Date	Rev.	Status or Amendment
28/08/17	A	Issue for DA Amendment

Pursuant to section 197 of the *Planning and Development Act 2007*, approval is sought to amend development approval No. 201630289 dated 13/12/2016 as described at **Attachment A.**

Project: Canberra Labor Club Belconnen Hotel
Blocks: 8+9 | Section: 48 | Division: Belconnen
Drawing Title: Ground Floor Plan
Job No.: 16_35 | Drawing No.: DA-A101 | Scale: 1 : 100@A1 | Rev.: F

Drawing Title: Level 10 Commercial Floor Plan

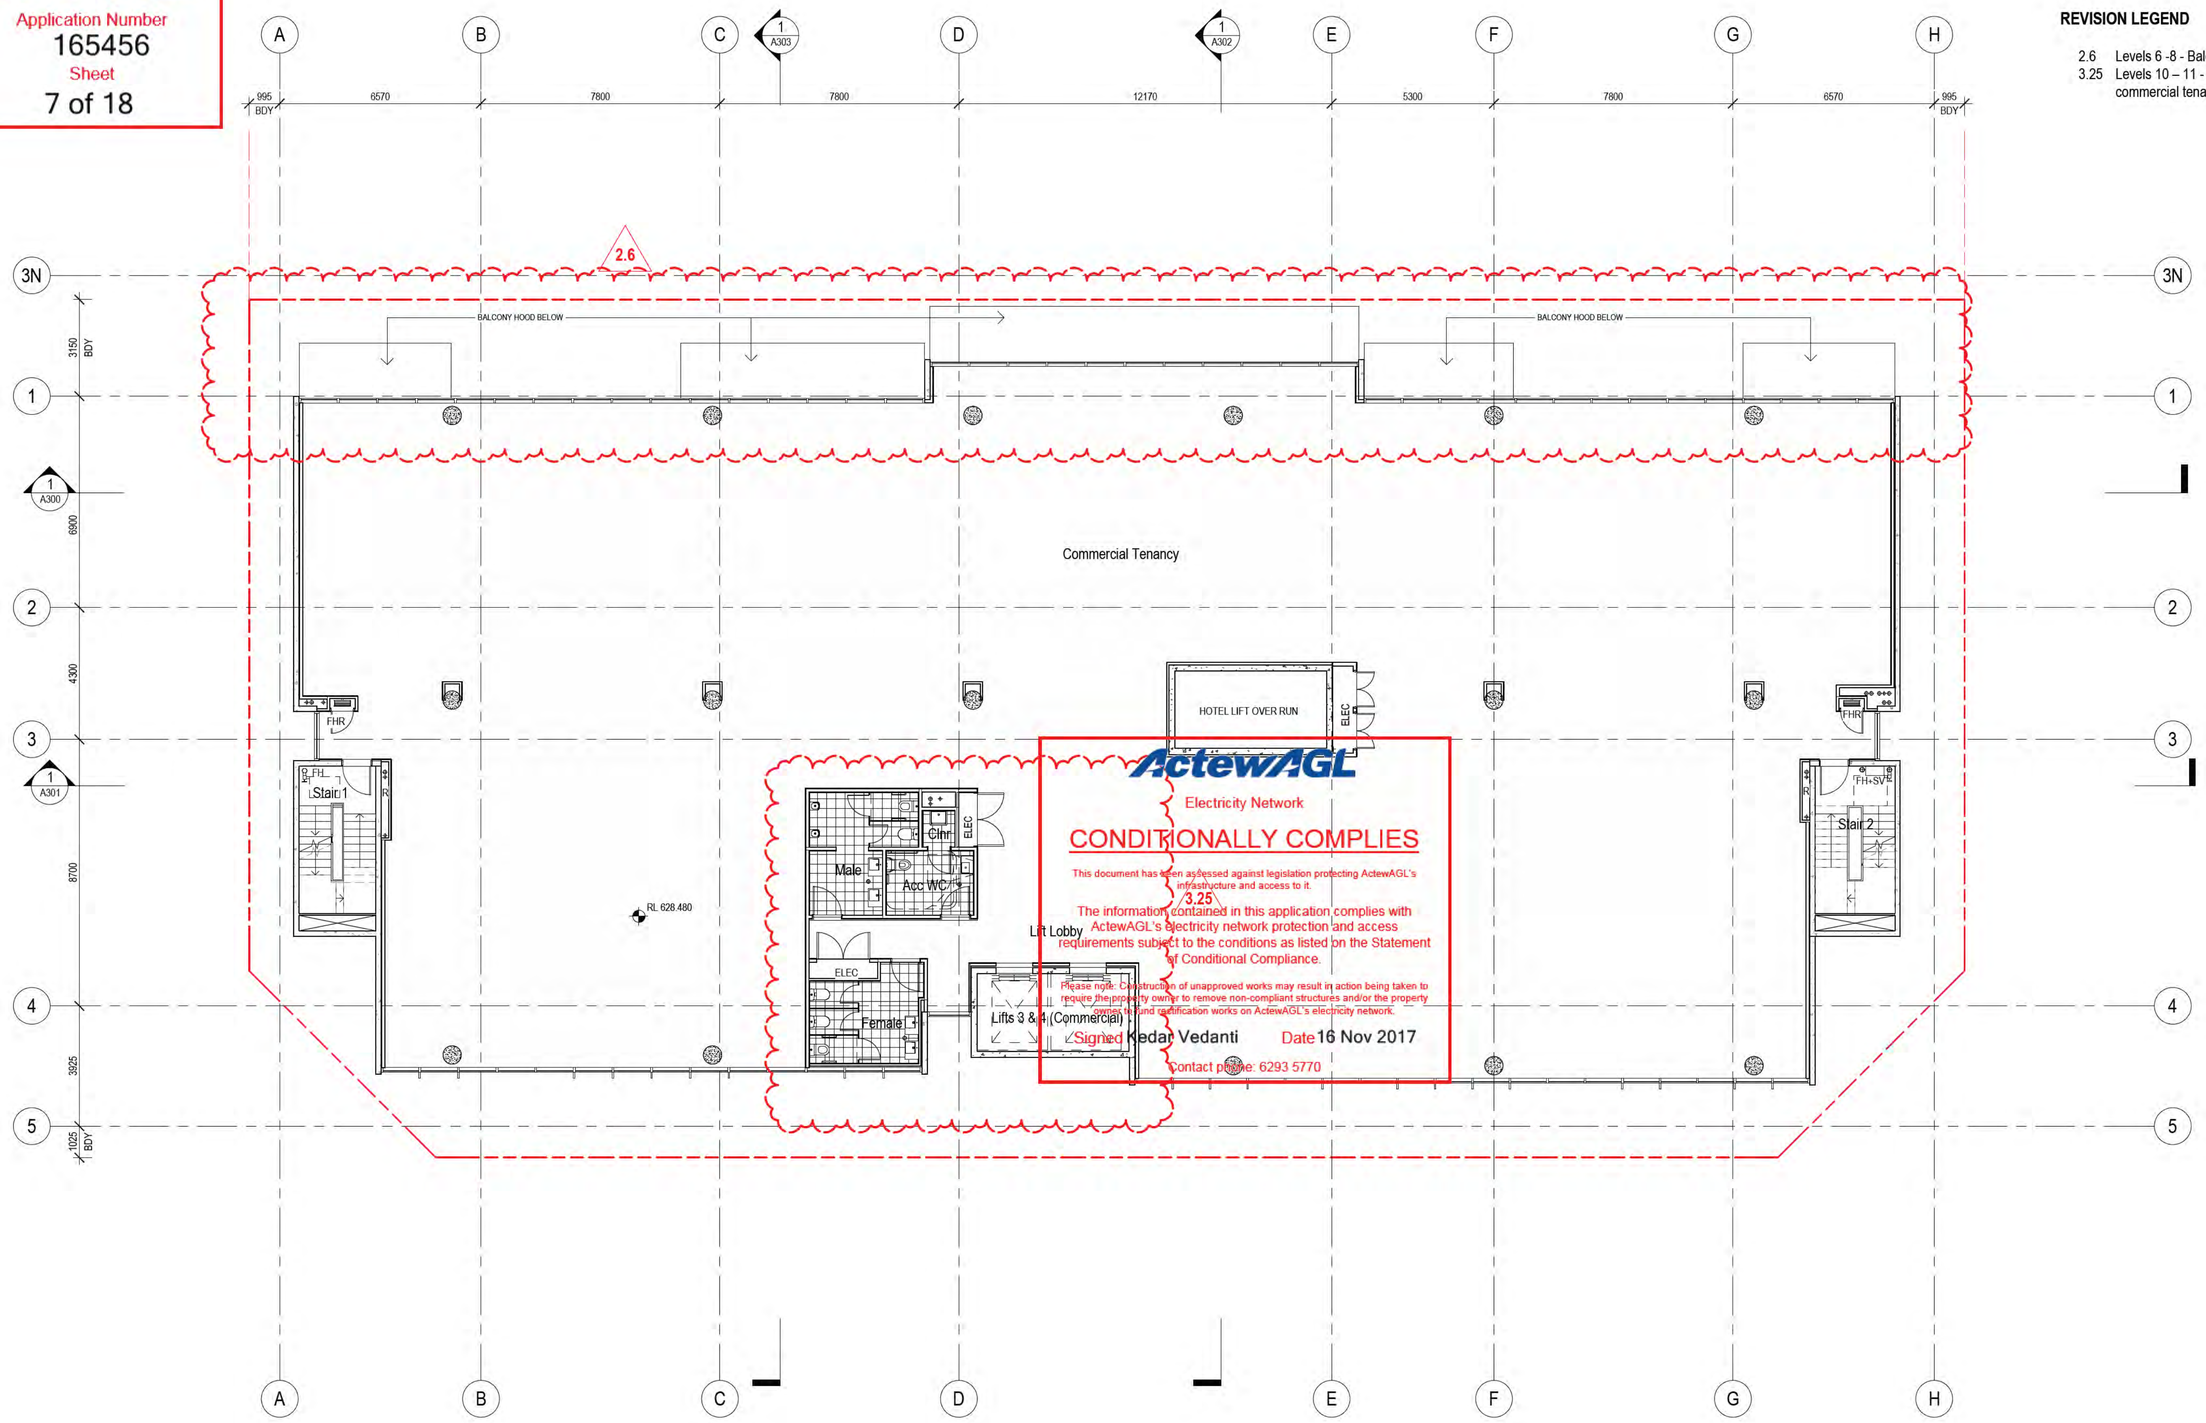
2.6 Levels 6 -8 - Balconies added to the northern façade.
3.25 Levels 10 – 11 - Core re-design to suit more appropriate commercial tenancy layouts.

Drawing Title: Level 9 Hotel Floor Plan

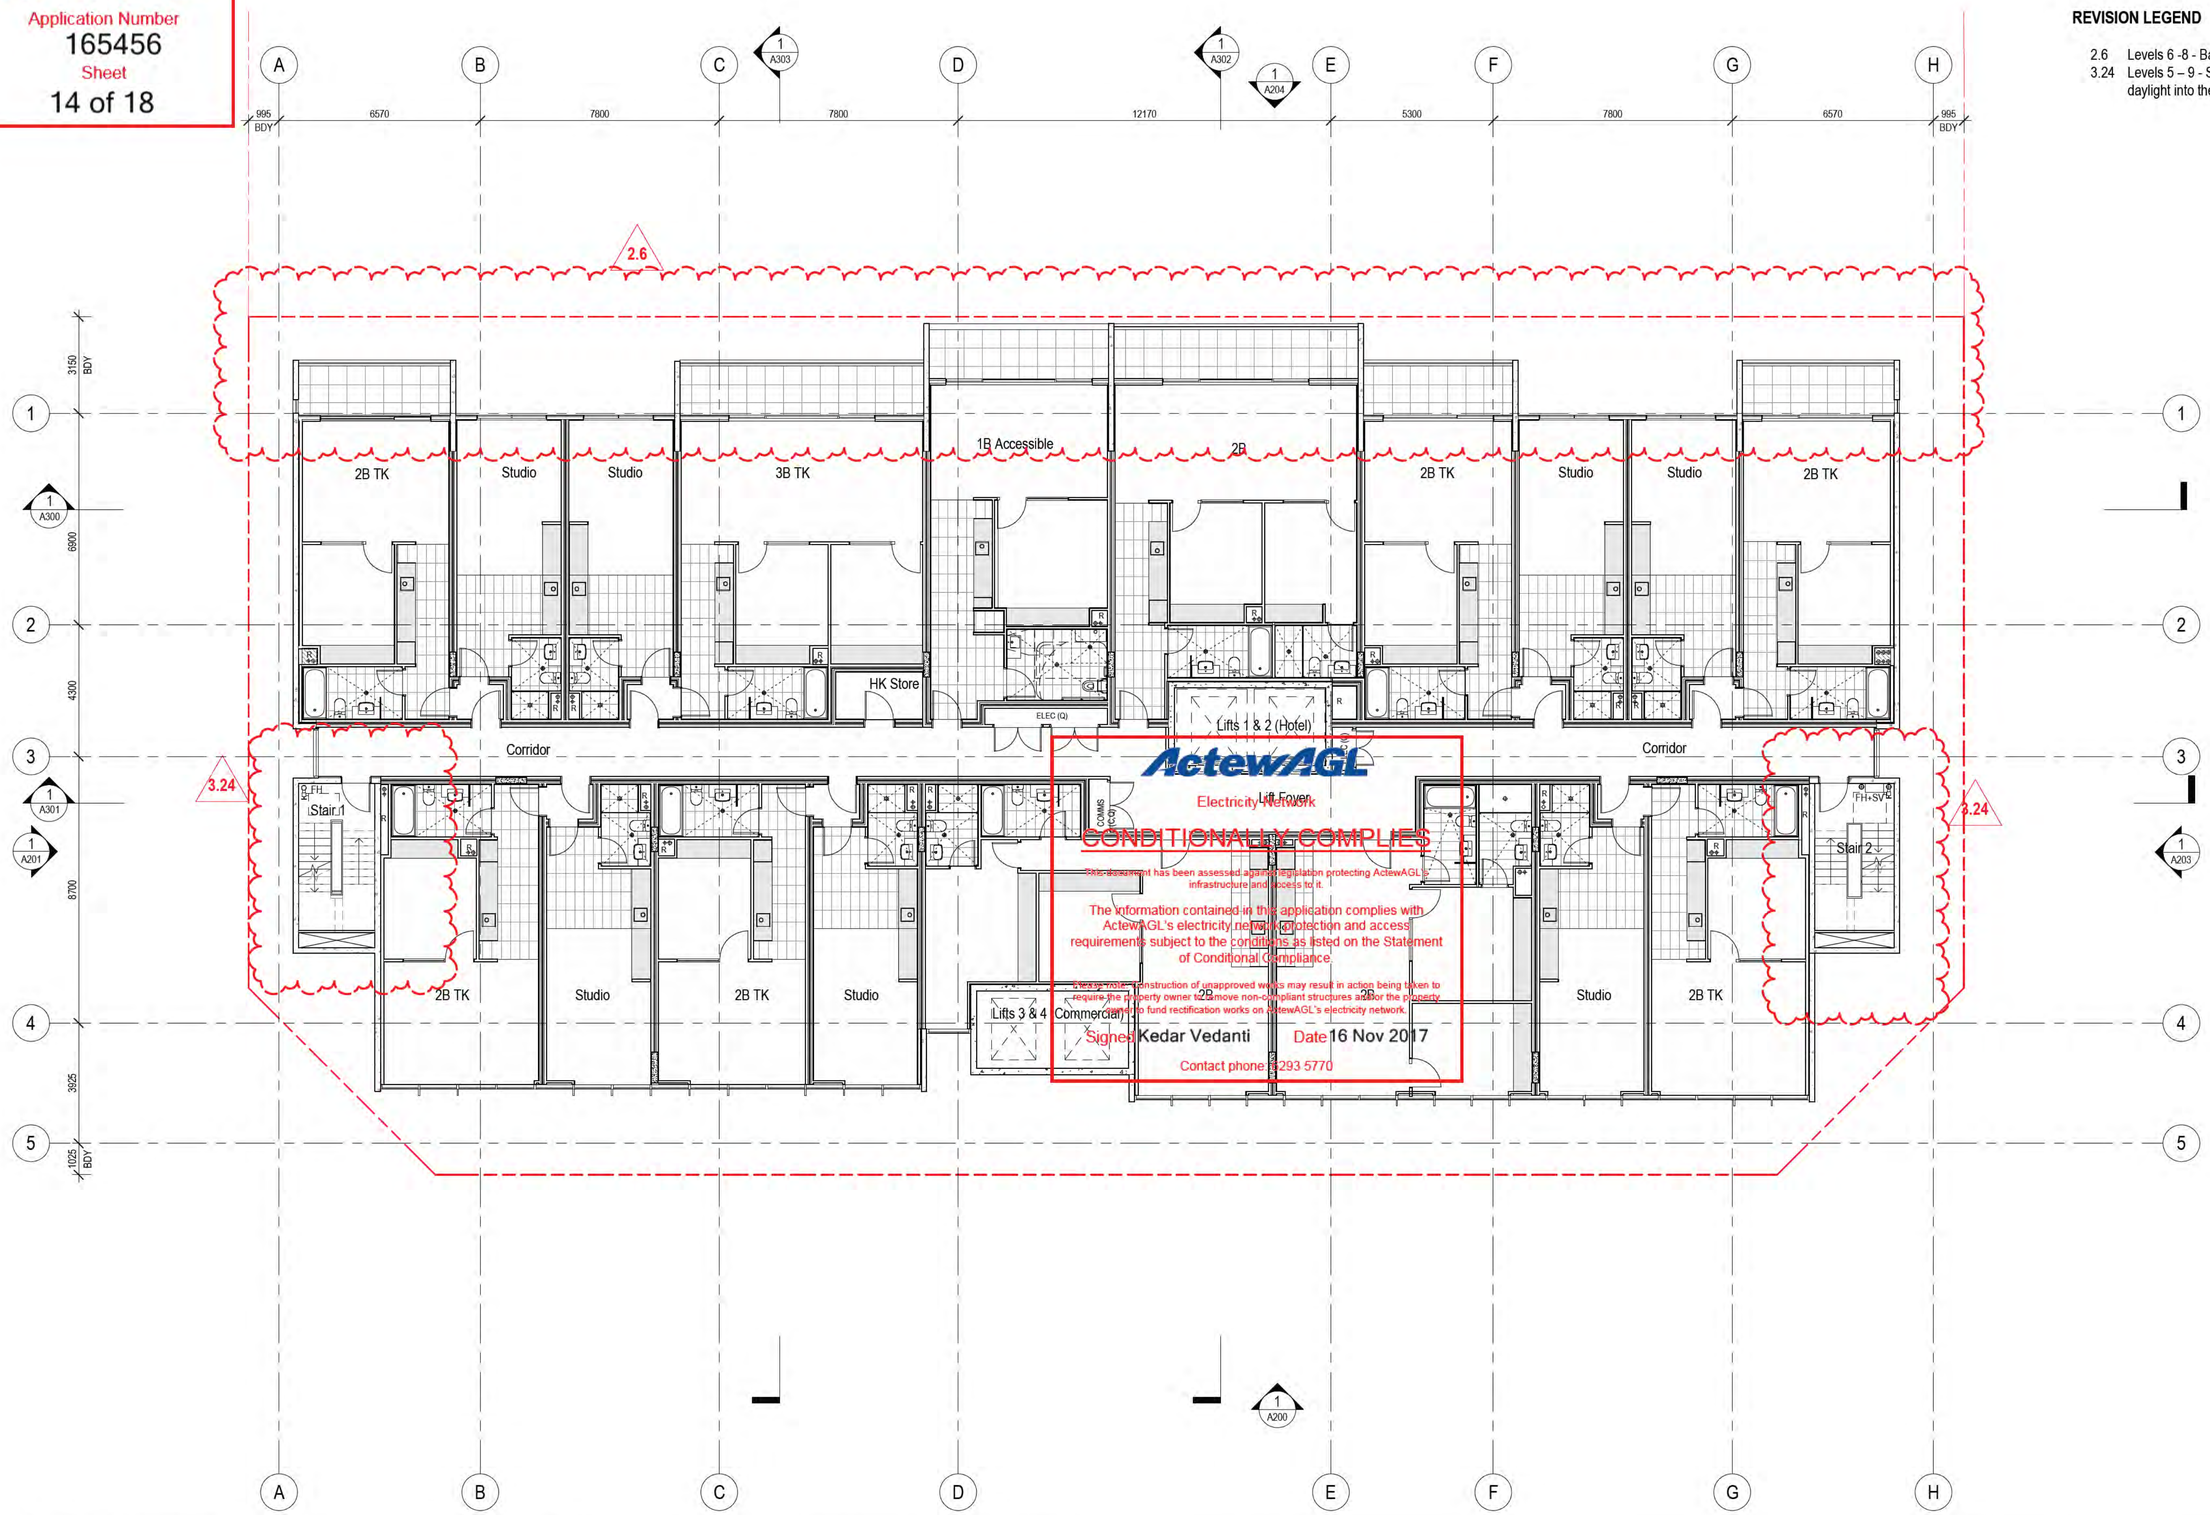
2.6 Levels 6 -8 - Balconies added to the northern façade.
3.24 Levels 5 – 9 - Stair Nos. 1 - 2 moved to the south to allow daylight into the internal access corridor space.

Drawing Title: Levels 6-8 Hotel Floor Plan

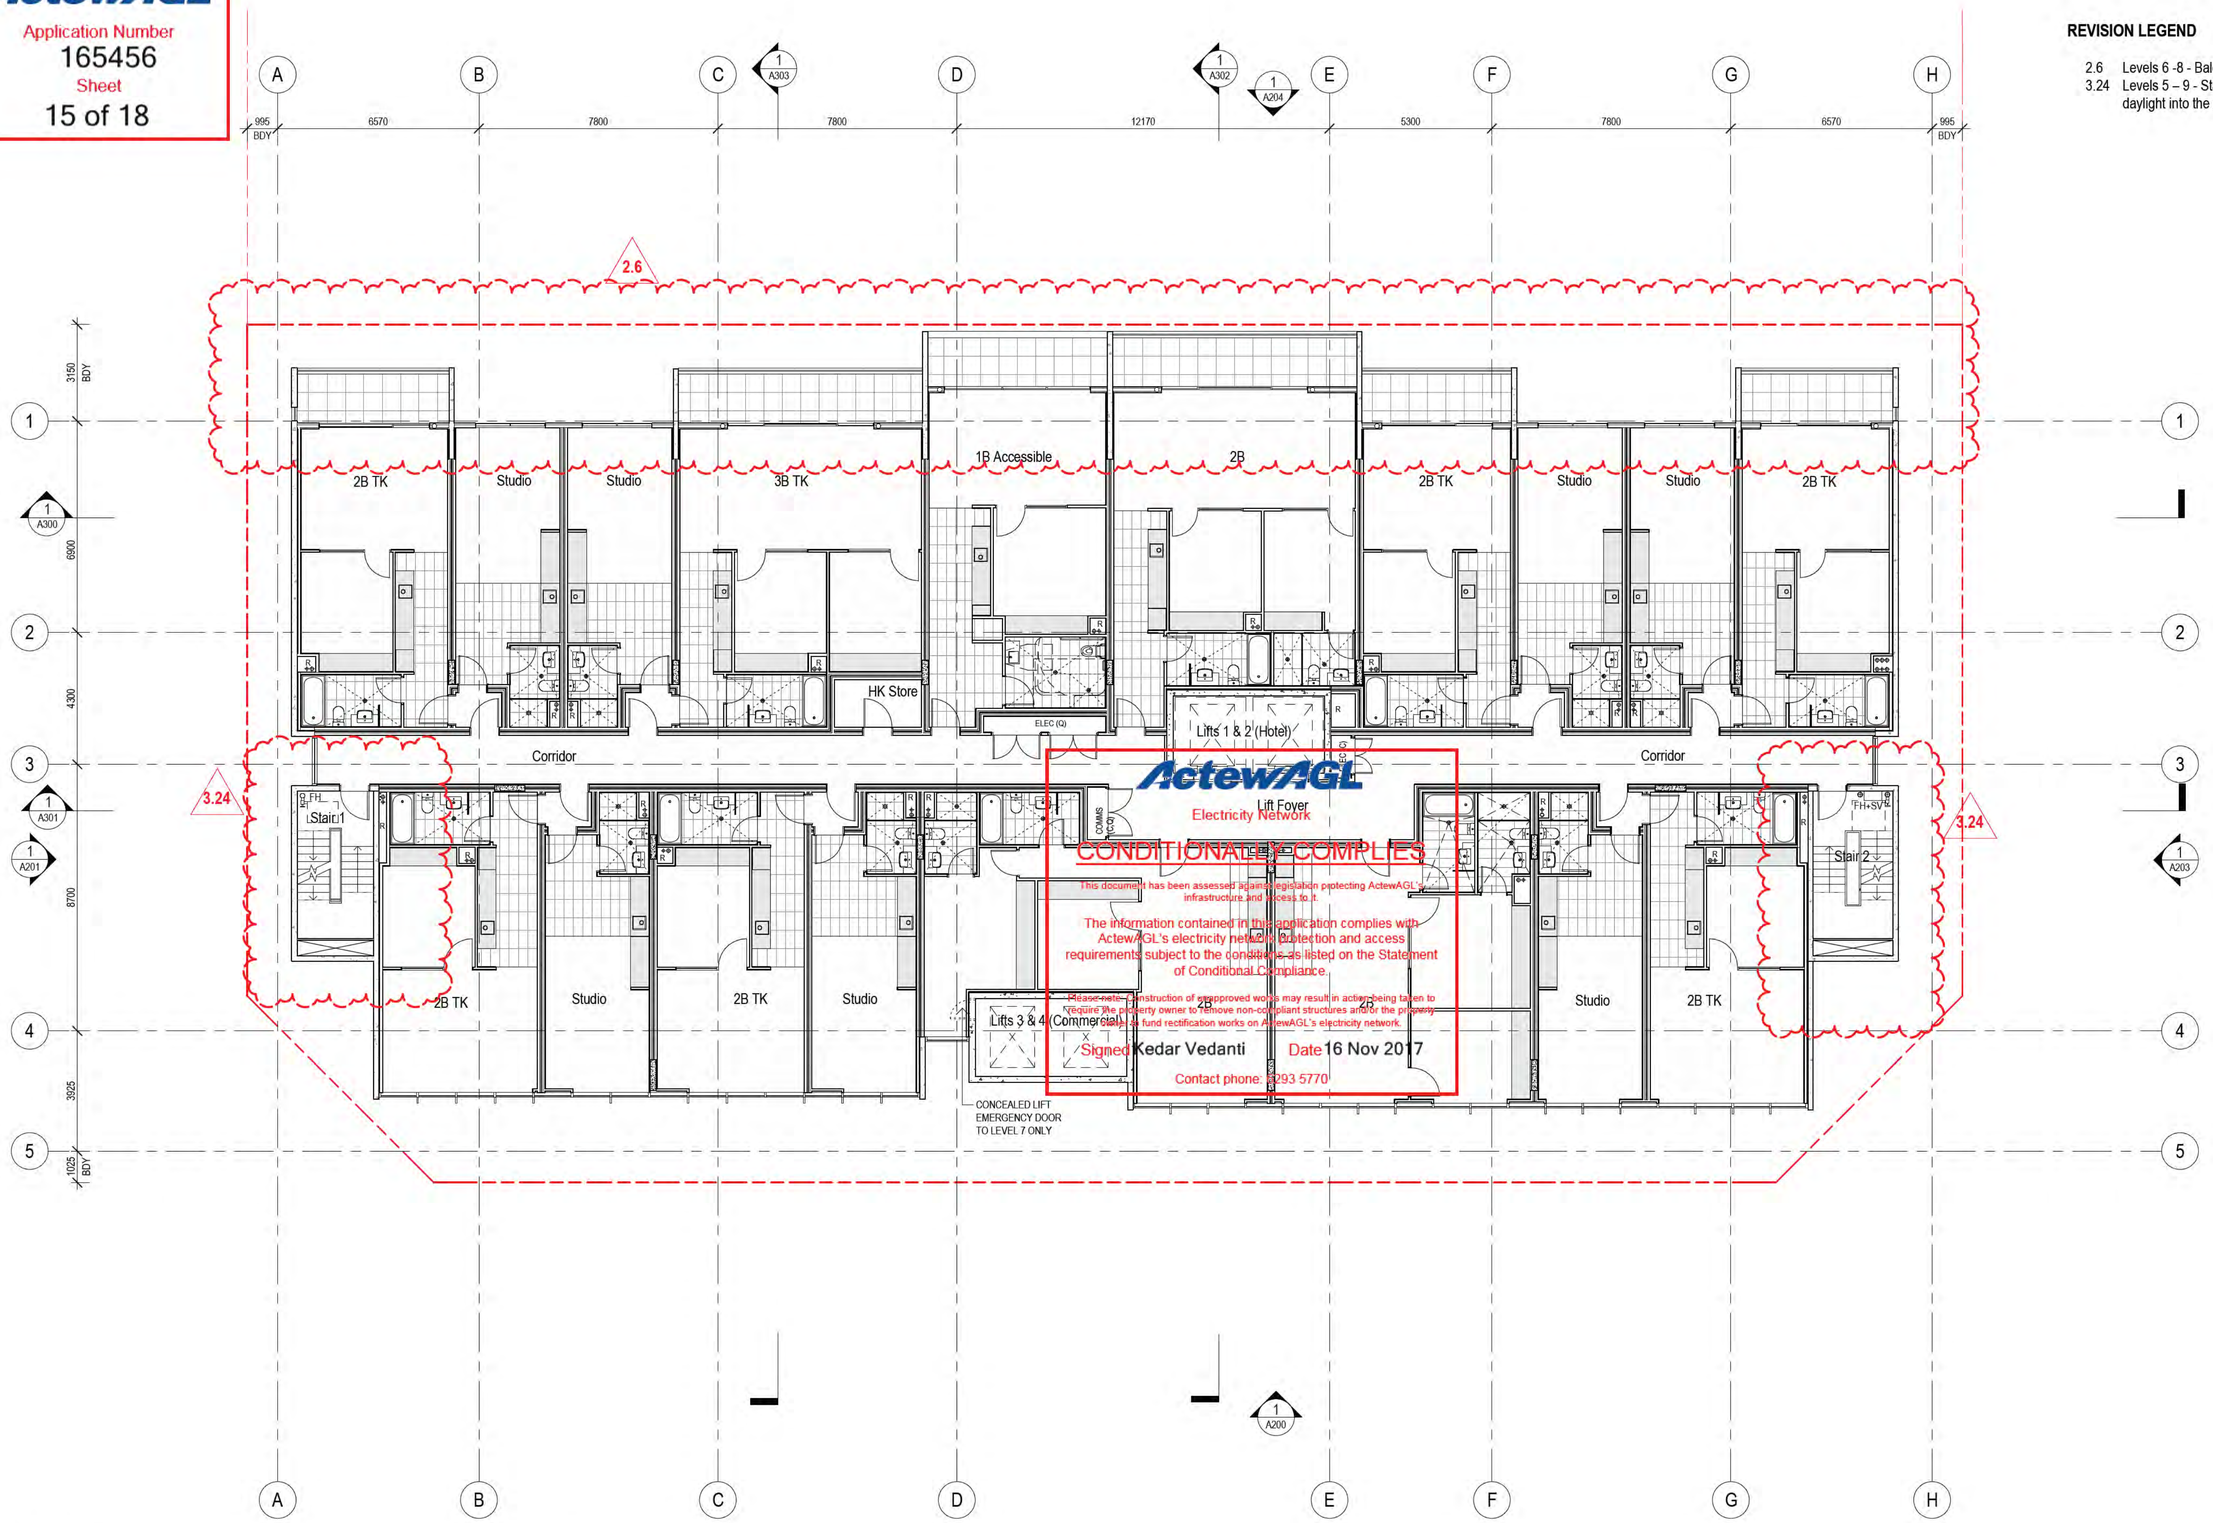
2.6 Levels 6 -8 - Balconies added to the northern façade.
3.24 Levels 5 – 9 - Stair Nos. 1 - 2 moved to the south to allow daylight into the internal access corridor space.
